APPENDIX - B

B-1: As Build Drawings (Summary)

B-2: Justification of the Modifications in the No.3 Bridge Slope Protection Work

Modification in the Design Concept of the No.3 Bridge Approach Road and Slope Protection Works

Figure 1 Anticipated geological condition and proposed slope stabilization works at the No.3 Seri Bridge Site Slope in the Detailed Design Stage

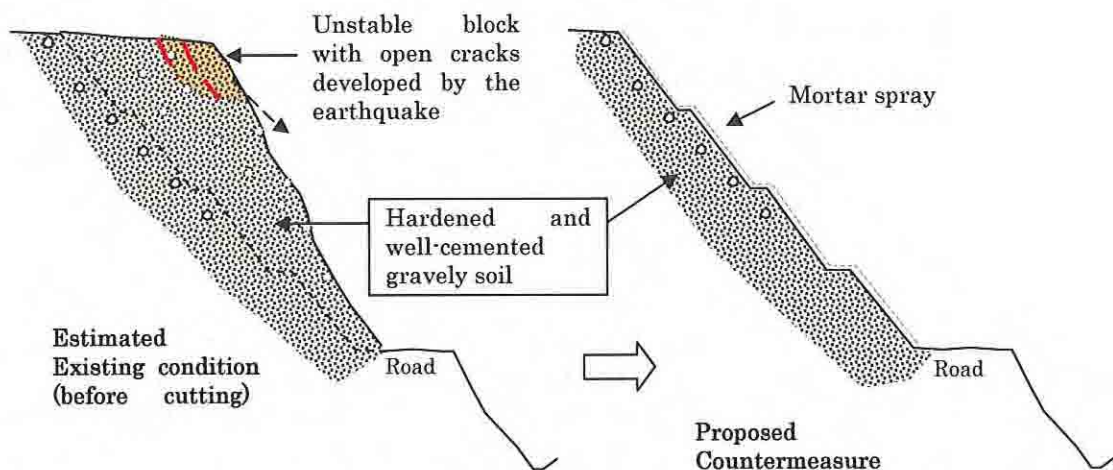
In the Detailed Design, cut slope of 1:1.0 with mortar spray was selected for slope stabilization of the No.3 Seri Bridge Site slope, taking into consideration of the following geological conditions and the selection criteria of Slope Protection Works as recommended by Japan Road Association (JRA).

- Natural slope gradient: 1:0.8 to 1:1.0 (V:H)
- Hardened and well-cemented gravelly soil can be classified as “Soft Rock” based on the observation of the existing slope surface.

Figure 2 Selection Criteria of Slope Protection Works Recommended by JRA

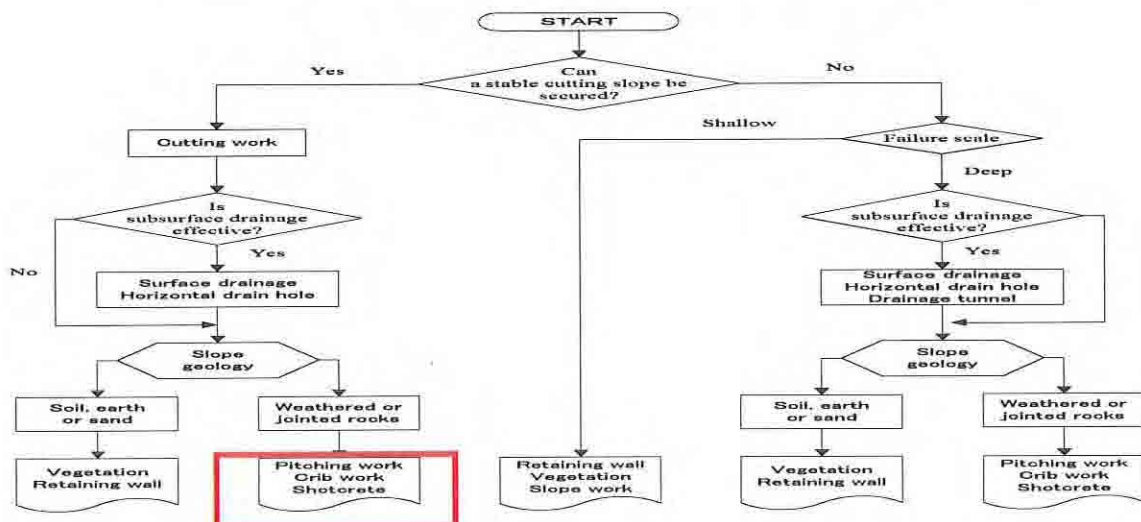
For such loose stiff clayey soil with sub-angular boulders, Mortar Spray Work is not applicable and the Crib Works should be selected as the countermeasure for slope stabilization in consideration to frequent rock falling due to erosion of soil surface as described in Figure 2 and Table 1 below.

Figure 3 Actual geological condition and proposed countermeasure

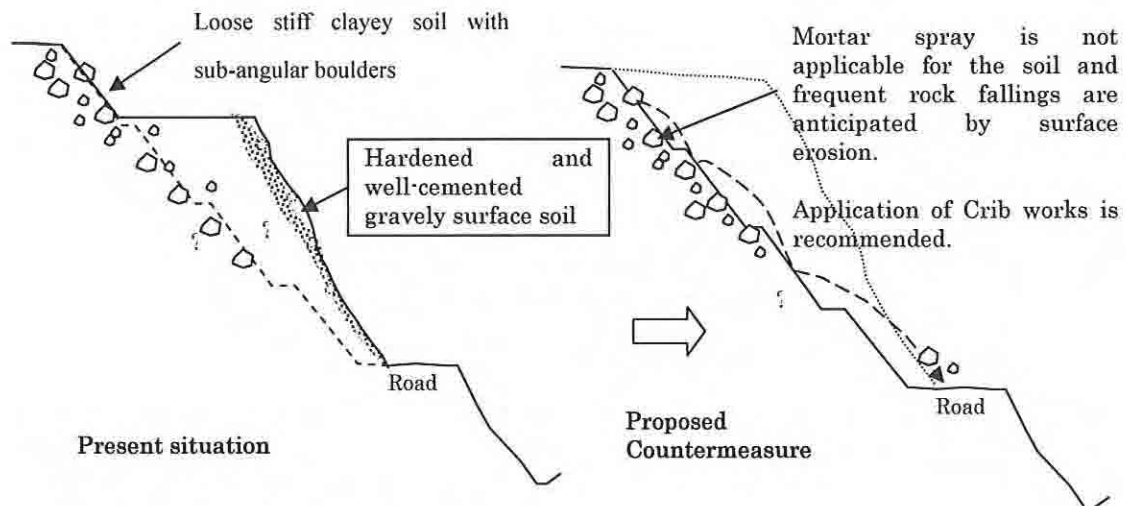
However, excavation of the slopes revealed that it consisted of loose stiff clayey soil with sub-angular boulders having diameter between 0.3 to 2.0m at the top step of the cut slope instead of the hardened and well-cemented gravelly soil.

Taking into account the budgetary constraint and cost-efficiency, it is recommendable to modify the concept of improvement of the site (the slope protection section) as below.

- To stabilize the existing slope by removal of the top soil loosened by the earthquake,
- To apply the suitable slope protection works for the cutting slope established by the above top soil removal work,
- To minimize cutting works along the existing road and carry out widening as much as possible within the existing road using common and locally available methods.

Based on the above modified concept, Nippon Koei would propose to change the improvement plan as shown in Figure 4, 5 and 6. Main points in the proposed modified plan are as follow:

- To sift the alignment at the corner using 25m radius curvature to avoid the massive cutting in the JICA Section,
- To extend the box-culvert about 5m in length and construct U shaped channel (Log Chute) about 66m in length,
- To widen the narrow section (G-F-E section) of the existing road toward valley side by filling work protected by gabion and founded on the U shaped channel,
- To widen the existing road (A-E section) as much as possible within the existing road using wet-masonry wall at mountain and valley side (see Figure 7, 8 and 9).
